MEMORANDUM

Subject: **Campus Planning Committee and Design Review Subcommittee Meeting,  
November 18, 2013**

## 2. Erb Memorial Union Expansion and Renovation Project – Schematic Design Follow Up

Erb Memorial Union Expansion and Renovation Project  
Schematic Design Follow Up  
November 18, 2013

EMU PROPOSED SITE PLAN

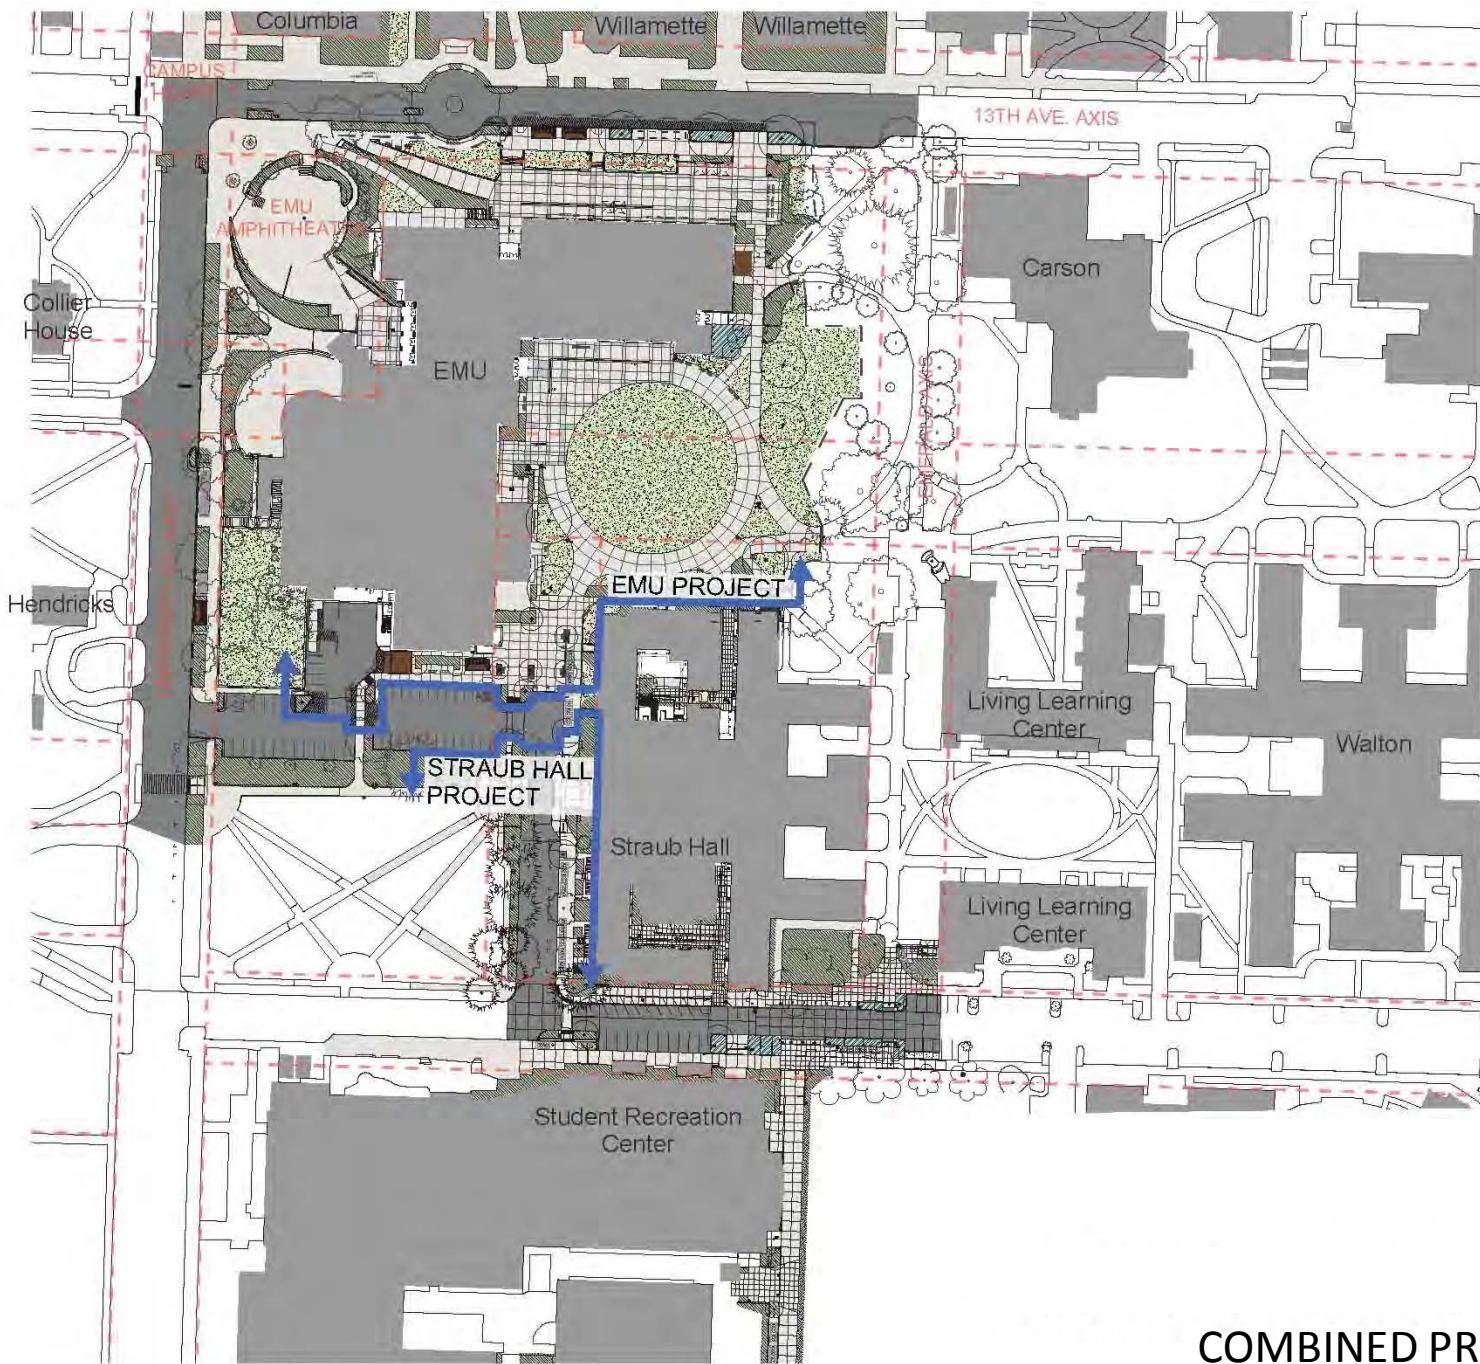
4. Relocated the US flagpole in the vicinity of its current location at the Amphitheater.
5. Changed the size, proportion, and roof coverage of the Craft Center's outdoor courtyard.

BUILT LANDSCAPE FEATURES

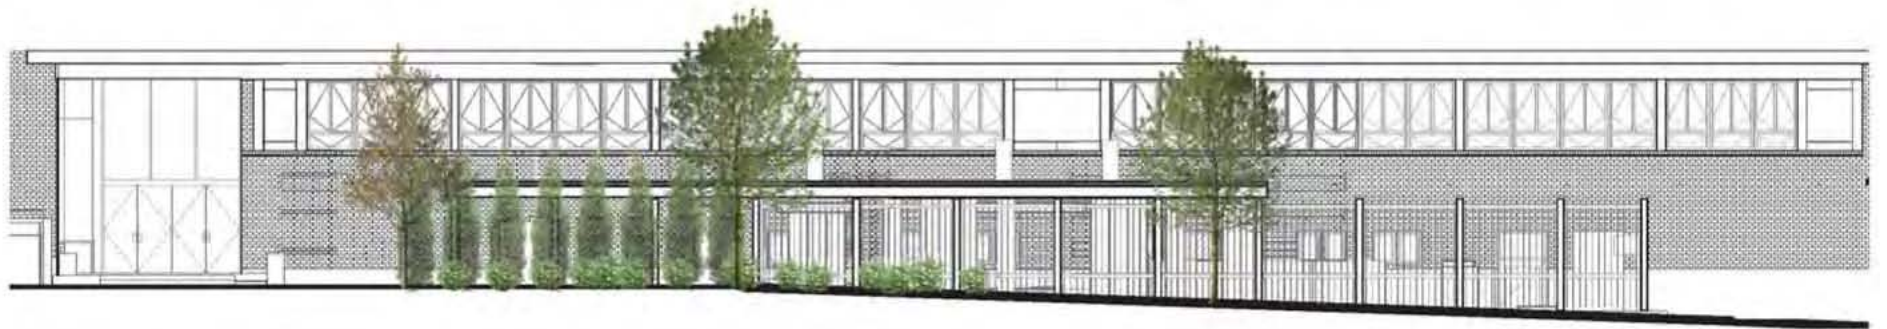
1. Refine the design of the covered bike parking facilities.
2. Refine the design of additional built landscape features (e.g. seat walls, stormwater planters, etc.) if any.
3. Carefully consider the design and materials for the Craft Center Courtyard outer fencing to ensure it is not "prison-like" in appearance. Consider materials other than metal mesh that are more consistent with other applications on campus, for example vertical metal fencing (similar to historic applications, e.g., at Dad's Gates and modern applications, e.g., at Powell Plaza), particularly for areas in public view.
